ADDENDUM NO: 4

Commodity: SU Ballroom AV

ADDENDUM 4

Project Name: Northern Kentucky University Student Union Ballroom Technology Room Upgrades

PARTIAL AV SYSTEM DIAGRAM — AUDIO — BALLROOM
Scale = NONE

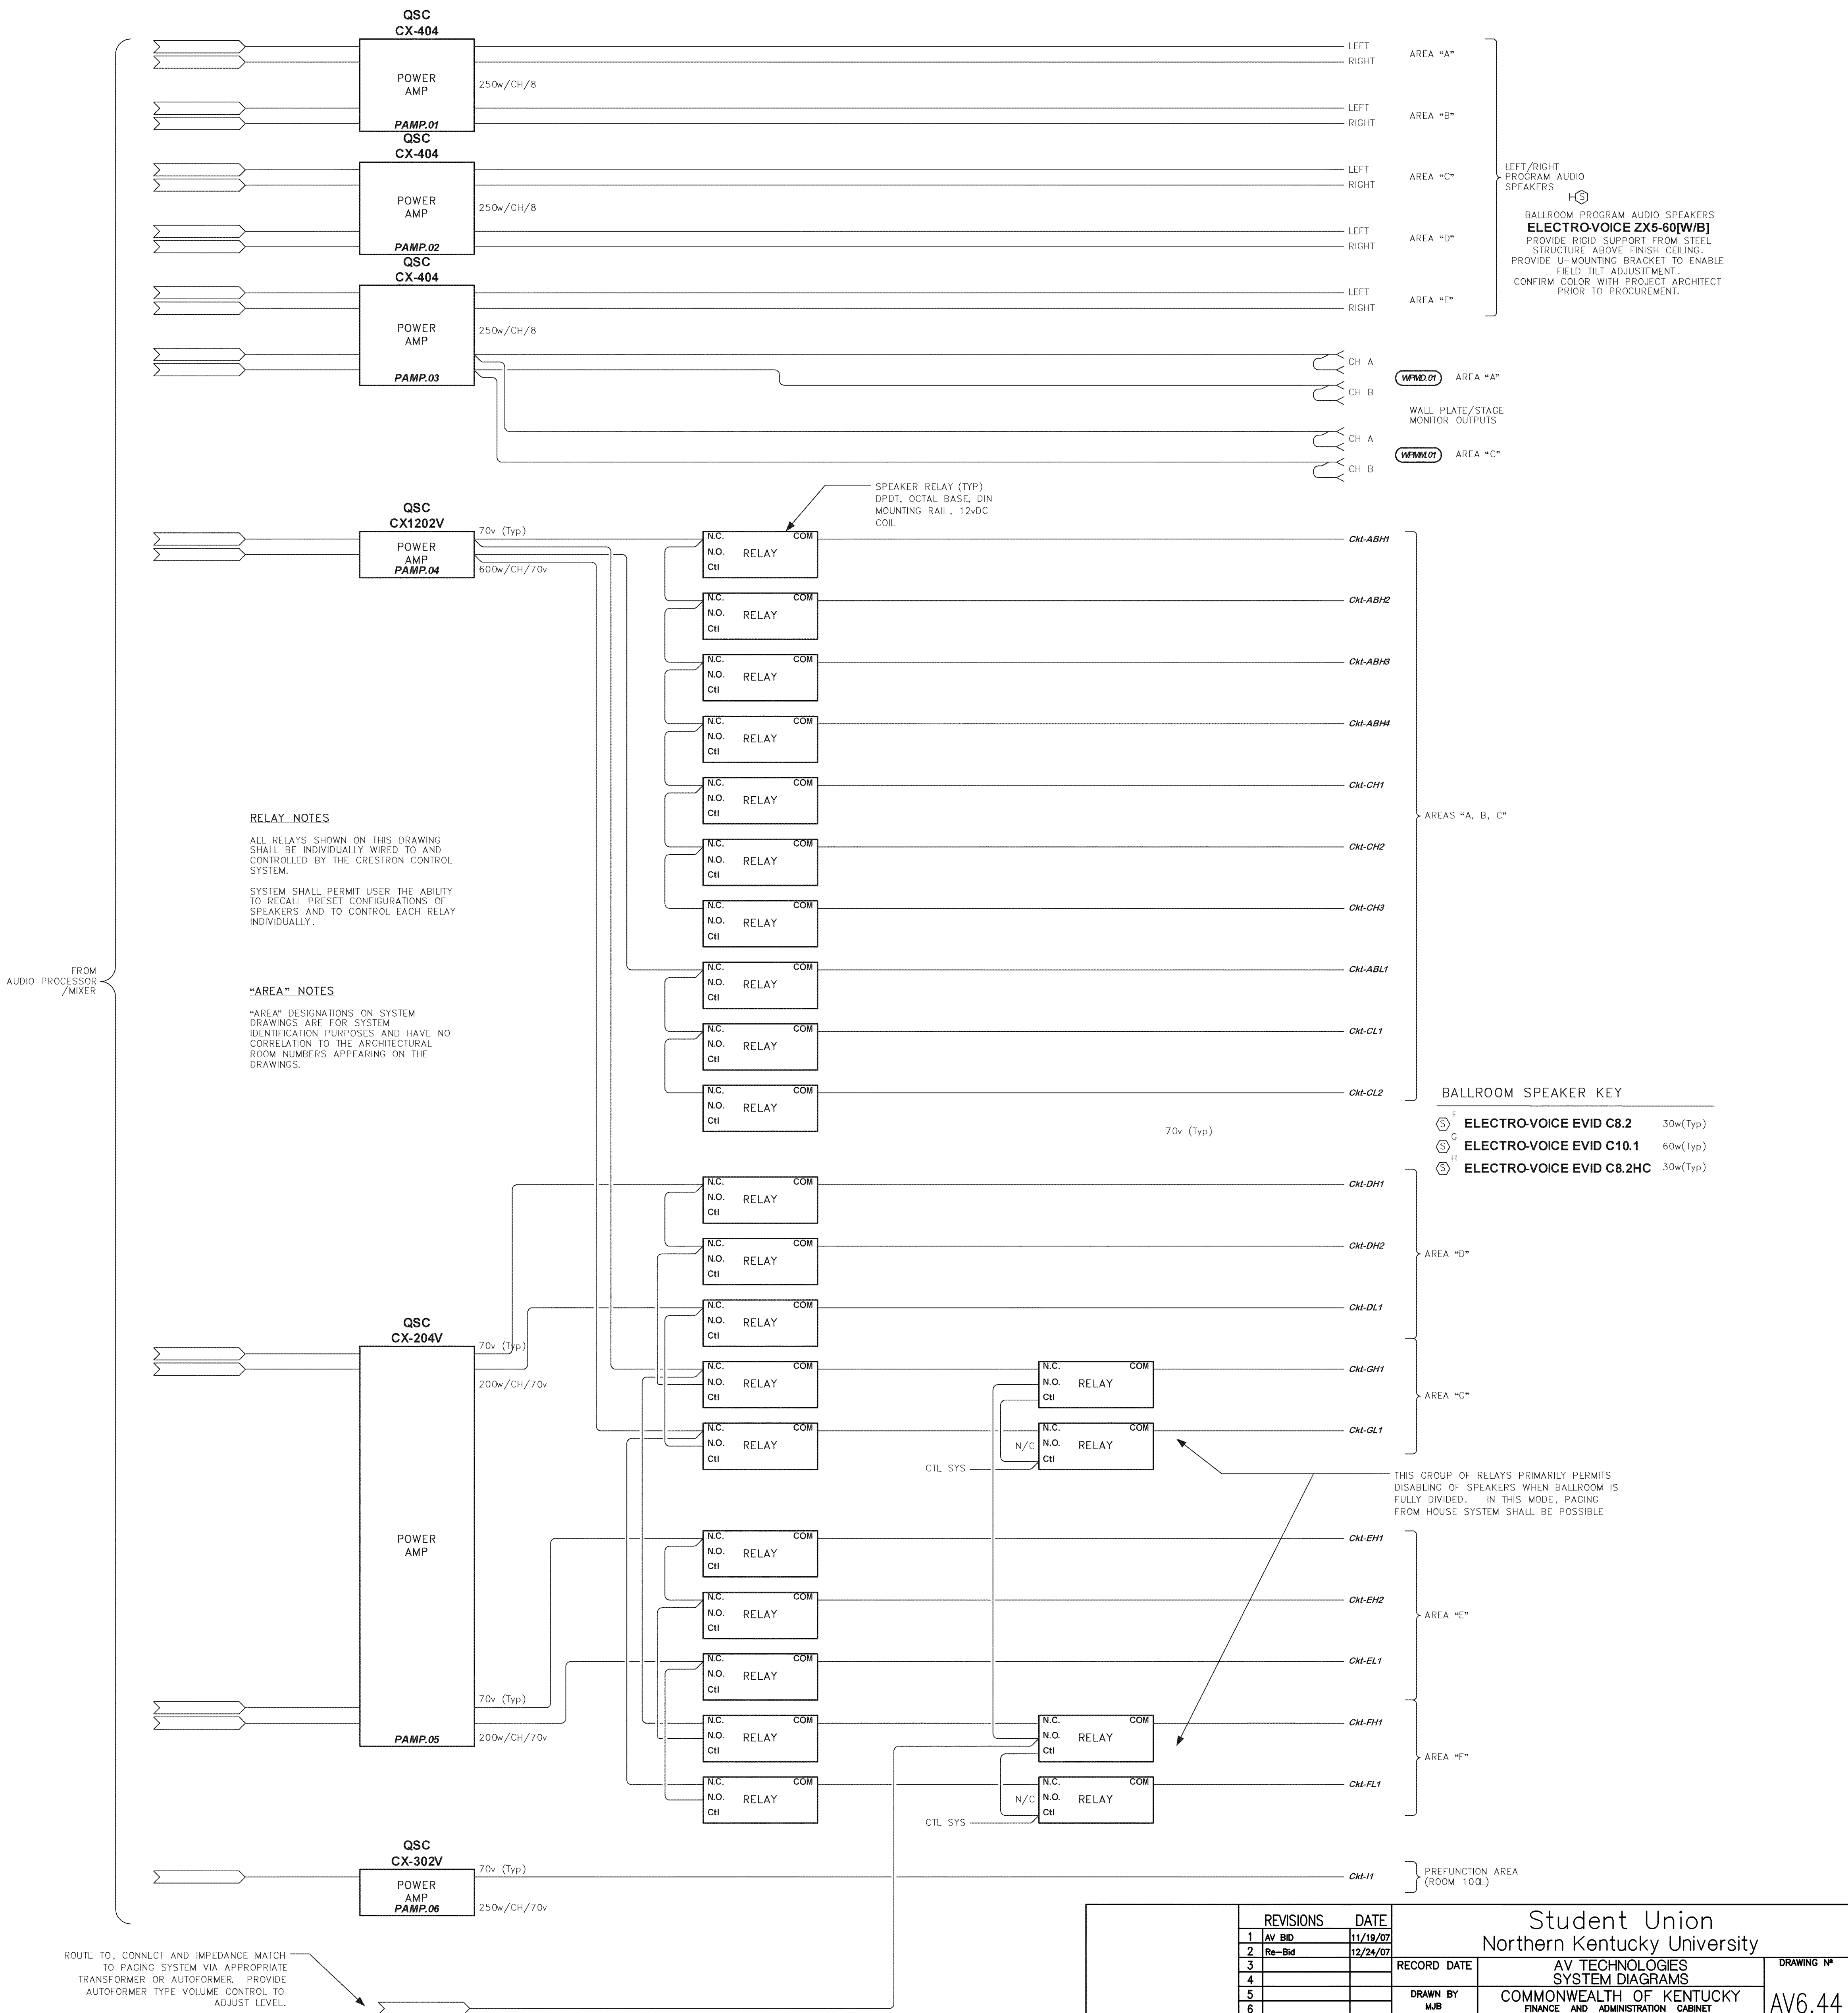
2. Is there an existing BOM of currently installed components?
 - a. See question 1 Response.
3. What is the make and model of existing speakers?
 - a. Existing speakers are a mix of Electro-voice products. See AV6.44 of the original design package for the model numbers requested in the original system. As referenced in the answer to question 1, these documents may differ from the currently installed components.

F-100

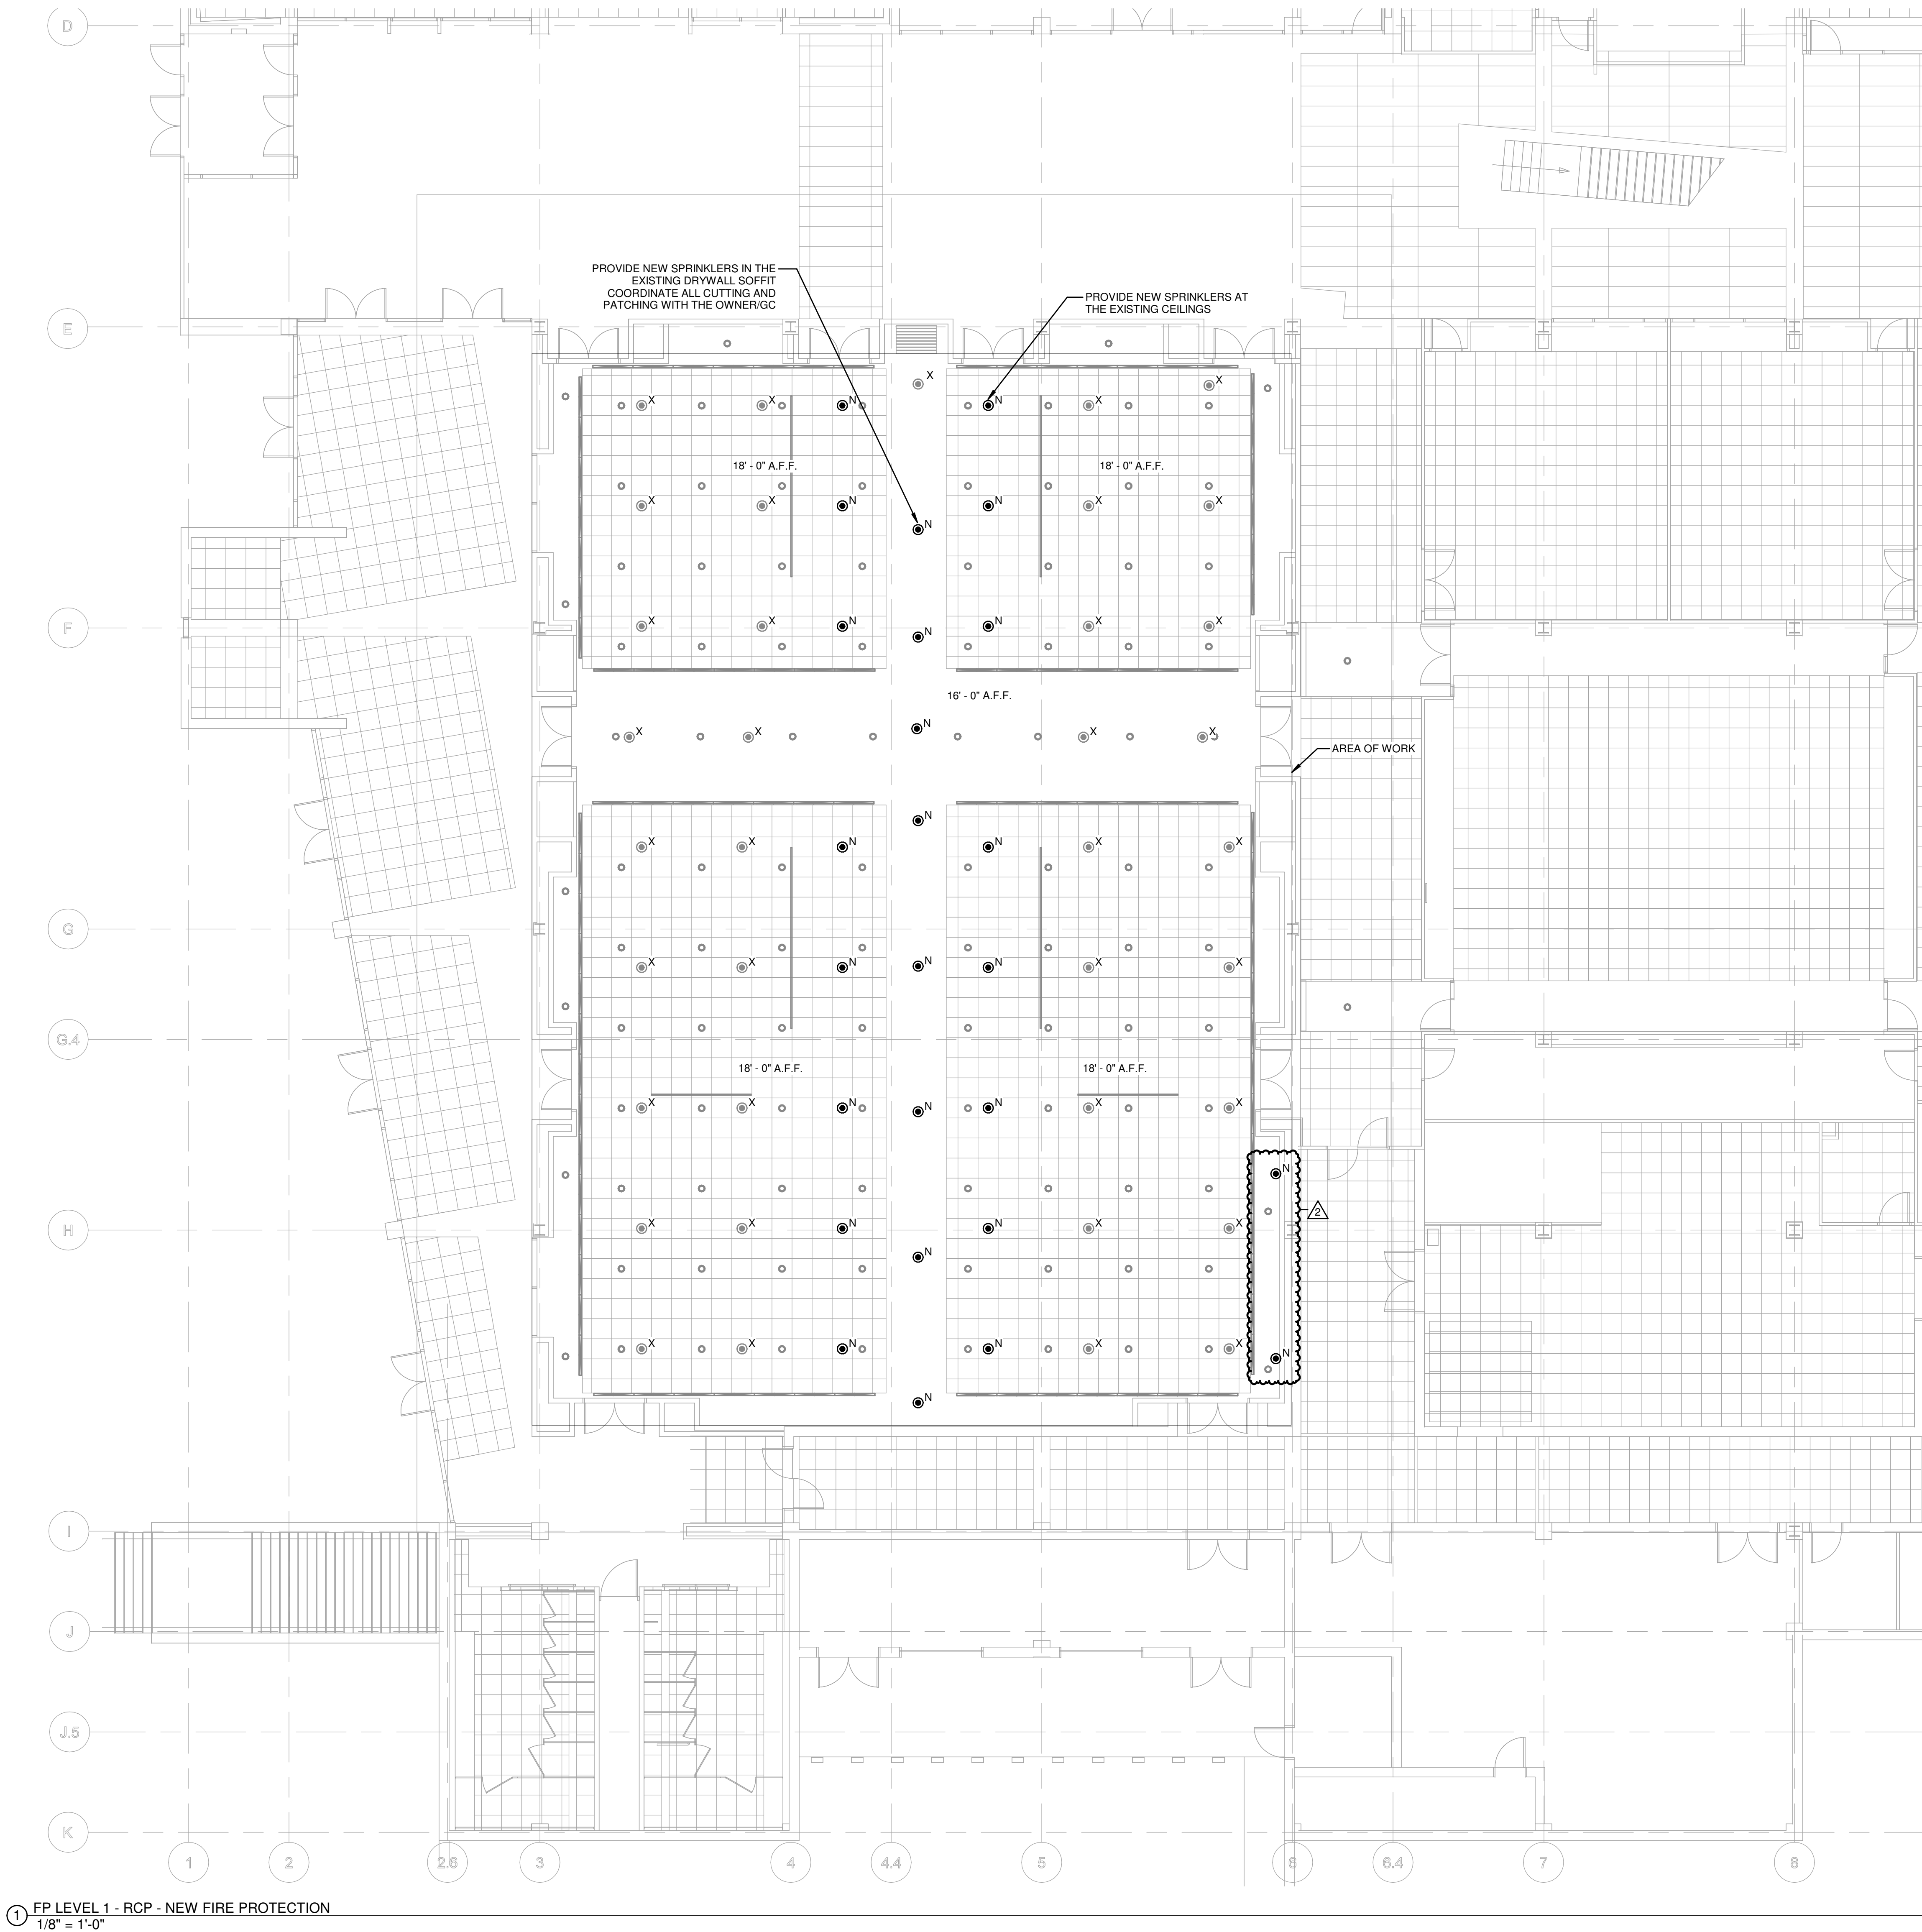
1. Sheet: F-100 - FIRE PROTECTION LEVEL 1 PLAN OVERALL
 - a. Relocate 2 sprinkler heads in the existing soffit areas for new screen installation.
2. Sheet: FD101 - FIRE PROTECTION DEMOLITION LEVEL 1 PLAN OVERALL
 - a. Added 2 sprinkler heads to be removed for new relocation shown on sheet F-100.
3. Sheet: T-642 - TECHNOLOGY SCHEDULES AND DIAGRAMMS
 - a. Updated intercom patch panel requirements.
